Changes to Induce Test & PD Measurement and Acceptance Limits

Text approved by RLFT and DTSC during S2023 Meeting @ Milwaukee
Ajith M. Varghese 03/26/2023

C57.12.00-2021

Figure 2 —Induced-voltage test for Class II power transformers

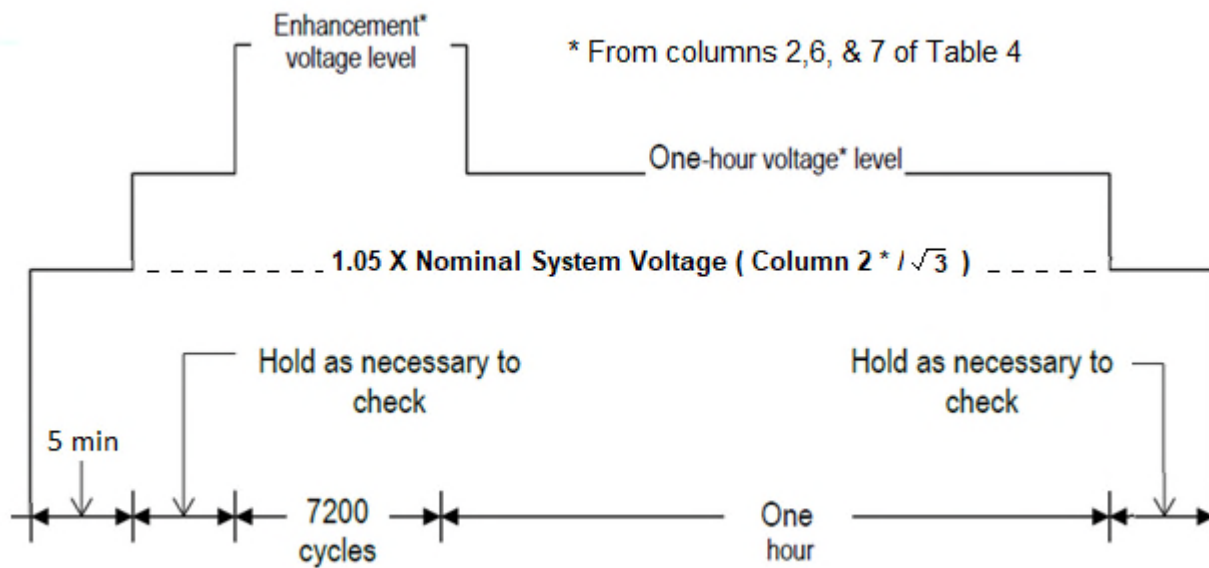
With the transformer connected and excited as it will be in service, an induced-voltage test shall be performed as indicated in Figure 2, at voltage levels indicated in Columns 6 and 7 and **1.05 times the line to ground voltage per column 2 of Table 4**. Minimum line-to-ground induced test levels for Class II power transformers shall be a multiple of corresponding line-to-ground nominal system voltage as follows: 1.58 times for one-hour tests and 1.8 times for 7200 cycles enhancement level tests.
